**PLAN COMMISSION PC #16-016
Marathon Gas Station/Convenience Store
1706 W. Northwest Highway
SU-Auto Service Station with Convenience Mart
Round 2**

Address: 1706 W. Northwest Highway
Marathon Gas Station/Convenience Store
Special Use Permit for Automobile Service Station with
Convenience Mart
P.C. 16-016 Round 2

Project: Marathon Gas Station with Convenience Store
1706 W Northwest Highway

Case Number: PC 16-016

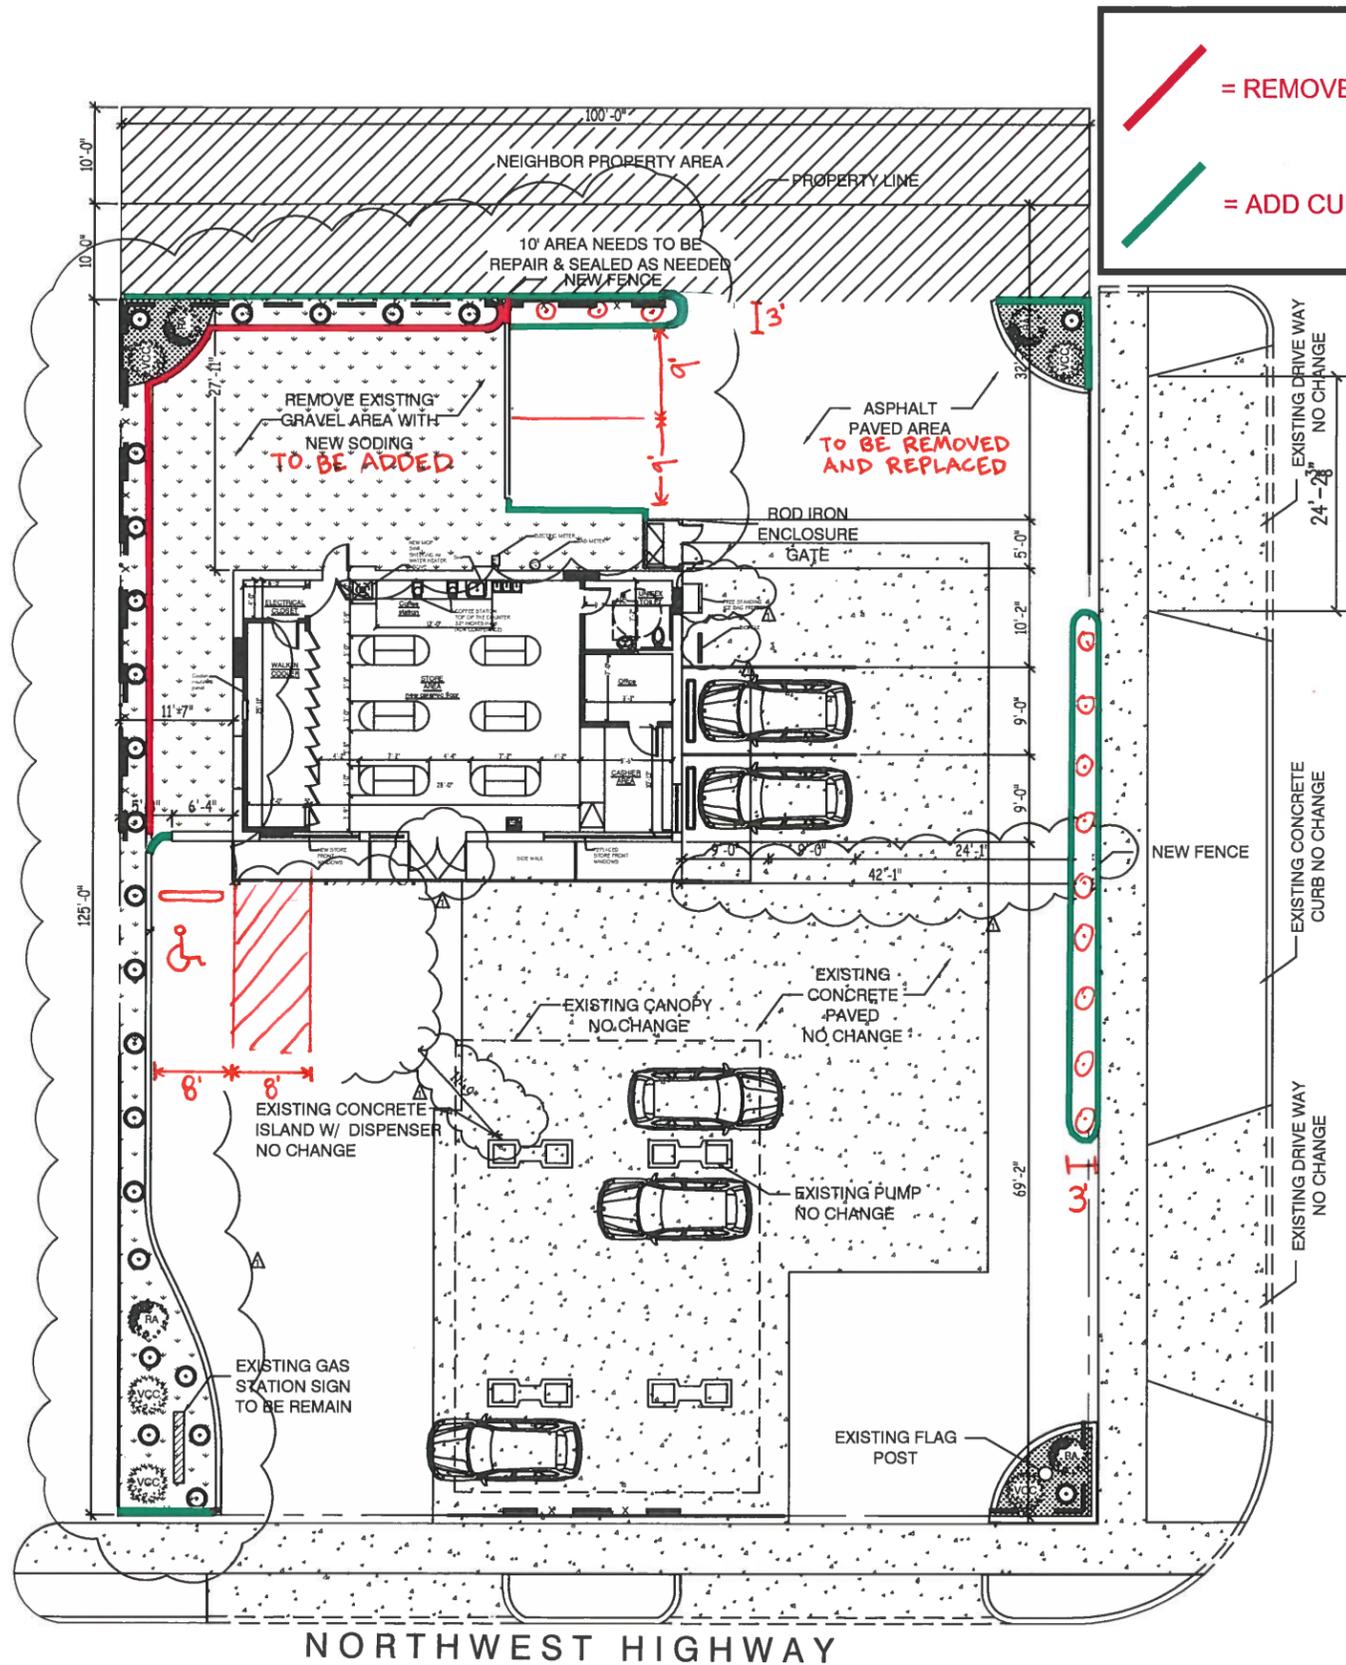
13. Handicap parking spaces are only required to be 8' wide with an 8' wide striped access pathway. The proposed handicap space appears to be 9' wide with a 9' wide access pathway. Please reduce the width of this space to be 8' wide with an 8' wide striped access aisle, which will allow for greater distance between the pump island and the edge of the parking space. Additionally, we recommend removing the parking space on the side to provide additional drive aisle space (see attached graphic).

14. The two parking spaces at the rear of the property appear to be 10' in width. Code only requires 9' wide minimum width for parking spaces. Please reduce the width of these spaces to be 9' wide to allow for the continuation of the landscape bed in this area (see attached graphic). The landscape bed should be 3' in width (not including curb), which may require the parking spaces to be shifted to the south. The fence should be located on the **outside** of the curb for the landscape bed.

15. Add a note to the "Asphalt Paved Area" indicating that the asphalt in this area will be removed and replaced (see attached graphic).
16. Add a note to the "Remove Existing Gravel Area With New Sodding" to clarify that the new sodding will be

added (see graphic).

17. Curbs must be provided around edges of the landscape beds. The curbs around the landscape beds that abut the newly sodded area should be removed (see attached graphic).

19. A 3' wide (not including curb) curbed landscape bed should be added along Race Avenue (see attached graphic). This will reduce the width of the drive aisle, but staff is supportive of a Variation to reduce this drive aisle width to accommodate the landscape bed.

2 NEW FENCE DETAIL TYPICAL
N.T.S.

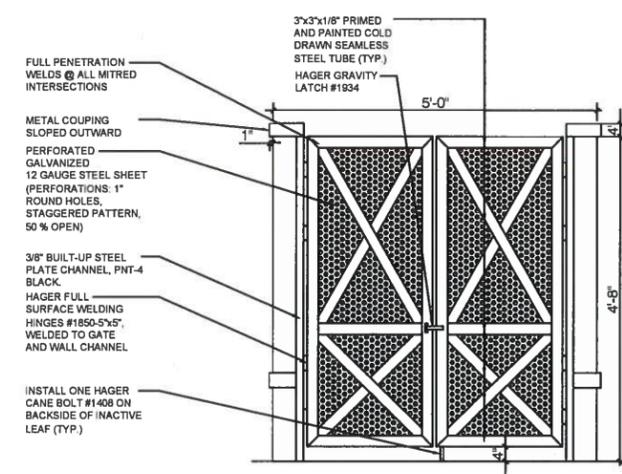
8. Please clarify if any new lighting will be proposed. If any new lighting is proposed, a photometric plan will be required.
9. The proposed 8' tall fence along the rear of the property must be reduced in height so as not to exceed 6'. Additionally, this fence should be a solid privacy fence so as to provide a full screen (i.e. spaces between the fence boards are not allowed). Please revise this graphic on the site plan.

10. The fencing in the front of the property along Northwest Highway and along Race Avenue is not allowed.
11. The fence along the side of the property (west) should be revised so that it is a 5' tall board-on-board fence. The proposed 8' tall fence in this location is not allowed. Please provide a detail for the 5' tall solid board-on-board fence, or add a note to the site plan indicating that it will be a board-on-board fence.

1 ELEVATION - PROPOSED TRASH ENCLOSURE WITH GATES
N.T.S.

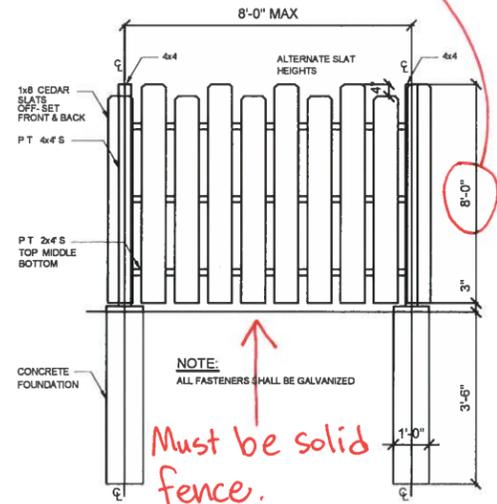
20. Please clarify the color of the metal panel that will be on the gate for of the dumpster enclosure. Will the panel be painted?
21. Information on the materials of the walls of the dumpster enclosure is required. The walls should be brick to match the materials of the building. No information on the walls of the dumpster enclosure have been provided.
